ATTACHMENT N1
HYDROGEN AND METHANE MONITORING PLAN

ATTACHMENT N1

VOLATILE ORGANIC COMPOUND MONITORING PLAN

Figure N1-1
Typical Substantial Barrier and Bulkhead

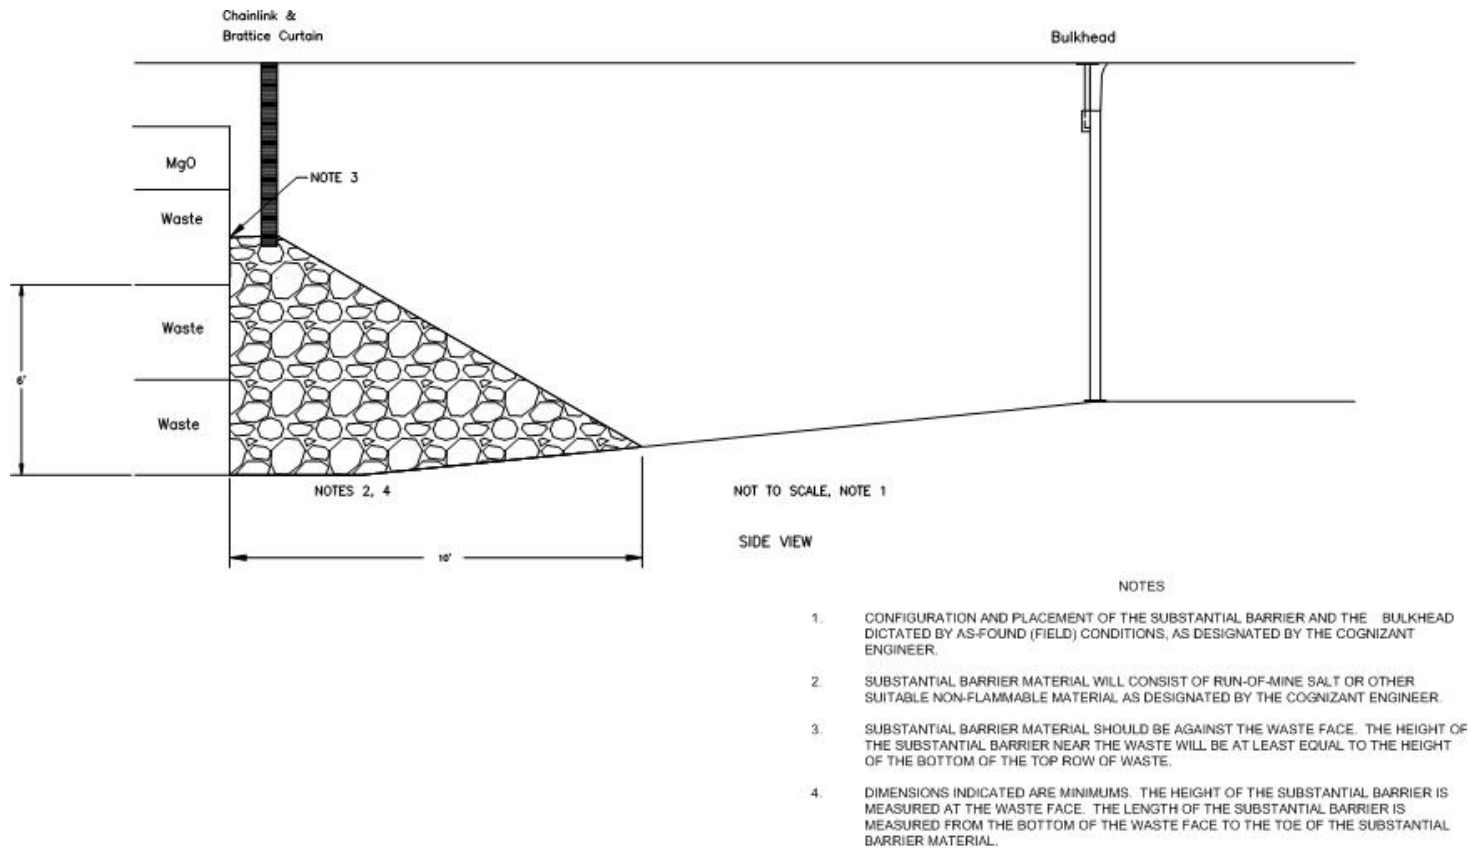
The substantial barriers serve to protect the waste from events such as ground movement or vehicle impacts. The substantial barrier will be constructed from available non-flammable materials such as mined salt (Figure N1-1).

Figure N1-2
Typical Bulkhead

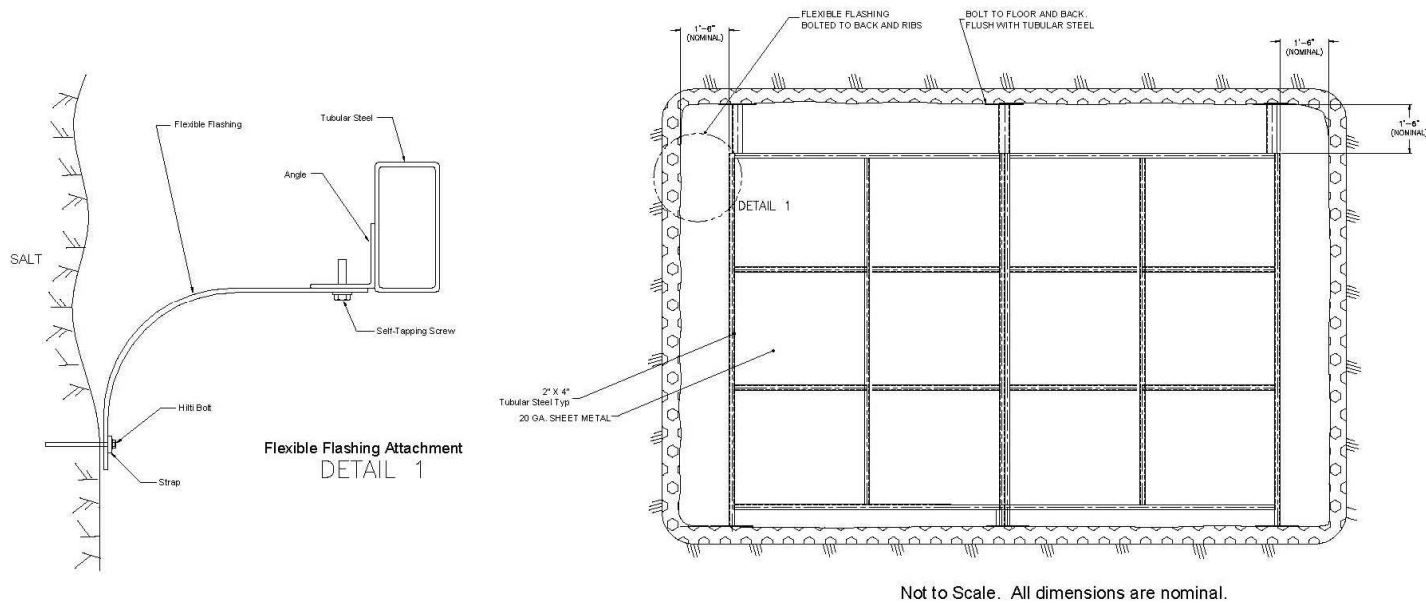
The bulkheads (Figure N1-2) serves to block ventilation at the intake and exhaust of the filled panel and prevent personnel access. The bulkhead is constructed as a typical WIPP bulkhead with no access doors or panels. The bulkhead will consist of a steel member frame covered with galvanized sheet metal, and will not allow personnel access. Rubber conveyor belt will be used as a gasket to attach the steel frame to the salt, thereby providing an effective yet flexible blockage to ventilation air. Over time, it is possible that the bulkhead may be damaged by creep closure around it. If the damage is such as to indicate a possible loss of functionality, then the bulkhead will be repaired or an additional bulkhead will be constructed outside of the original one.

Figure N1-3
Typical Hydrogen and Methane Monitoring System

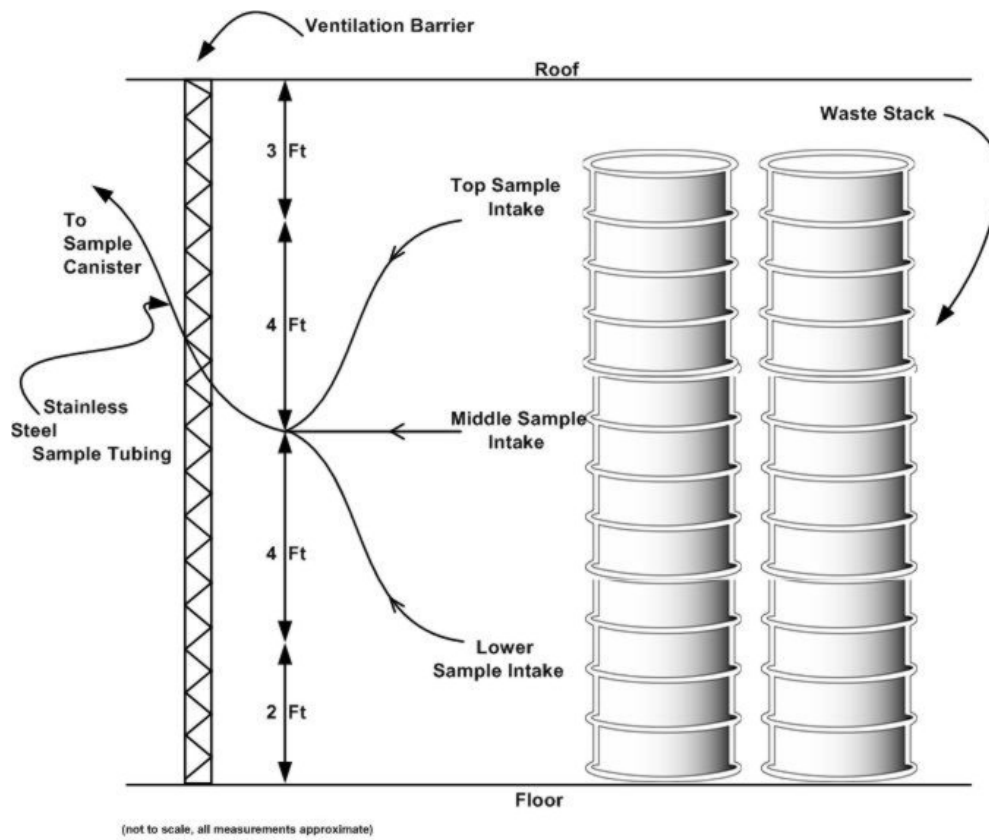
The existing VOC monitoring lines as specified in Attachment N, Section N-3a(2), "Sampling Locations for Disposal Room VOC Monitoring", will be used for sample collection in each disposal room for Panels 3 through 8. The sample lines and their construction are shown in Figure N1-3. In addition to the existing VOC monitoring lines, five more sampling locations will be used to monitor for hydrogen and methane. These additional locations include:

Figure N1-4
Typical Hydrogen and Methane Sampling Locations

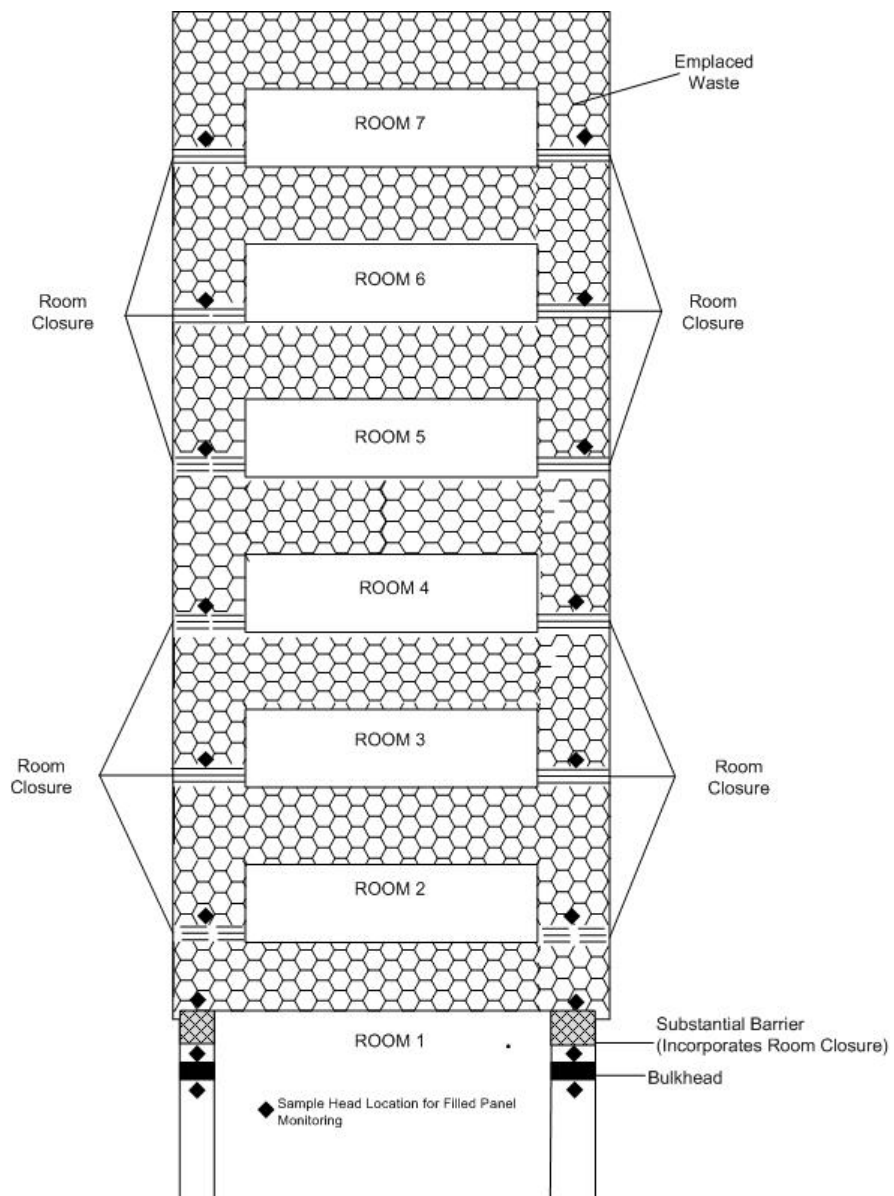
These additional sampling locations (Figure N1-4) will use a single inlet sampling point placed near the back (roof) of the panel access drifts. This will maximize the sampling efficiency for these lighter compounds.

Figure N1-5
Logic Diagram for Evaluating Sample Line Loss

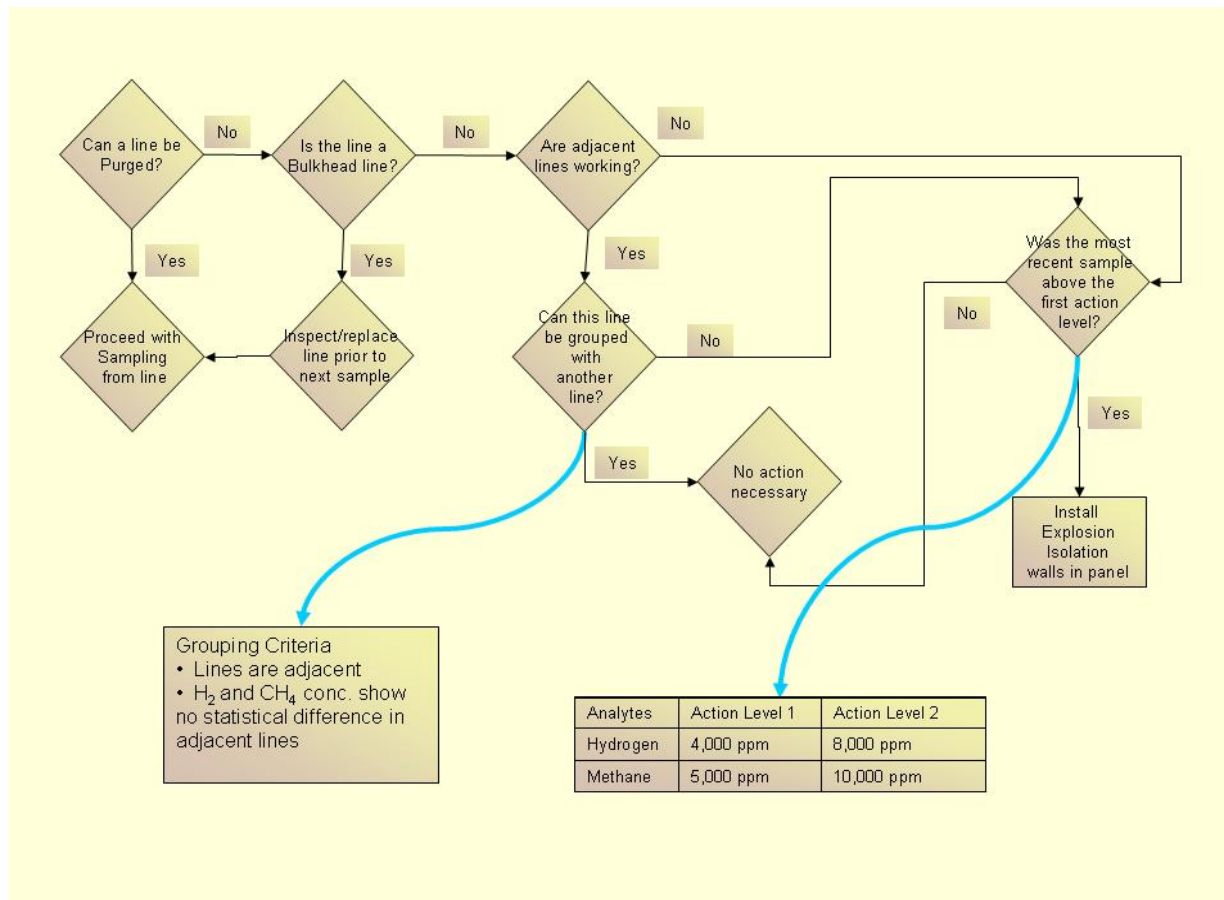
Any loss of the ability to purge a sample line will be evaluated. The criteria used for evaluation are shown in Figure N1-5.

If any sampling line loss occurs, notification will be made to NMED and the notification posted to the WIPP web page and accessed through the email notification system within seven calendar days of learning of a sampling line loss. After the evaluation of the impact of sampling line loss as shown in Figure N1-5, notification will be made to NMED and the notification posted to the WIPP web page and accessed through the email notification system within seven calendar days of completing the sampling line loss evaluation.
